ADDENDUM NO. 2

DATE: AUGUST 4, 2008

Project: 08-C-00033; Norfolk Street and Packwood Avenue Stormwater Improvements

CLASS C BEDDING

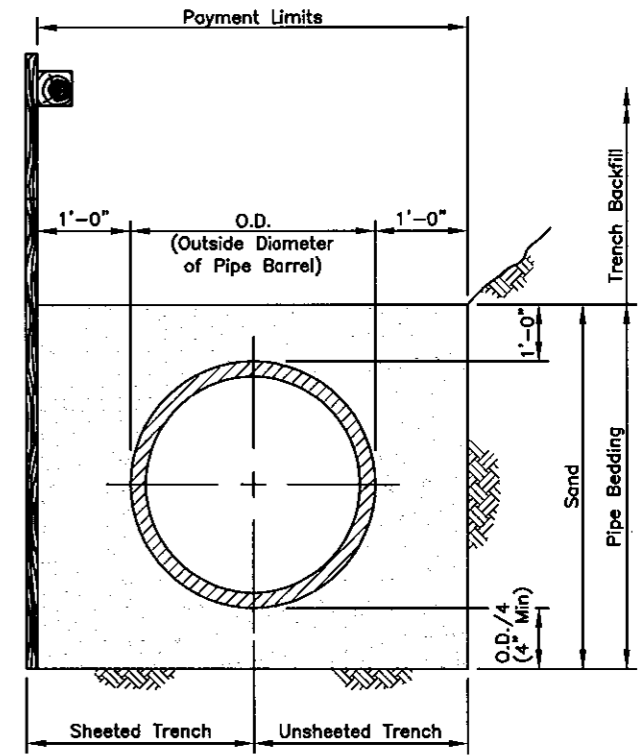
SP-134 Pipe Bedding

All pipe shall include Type C bedding as shown in the attached Bedding Details.
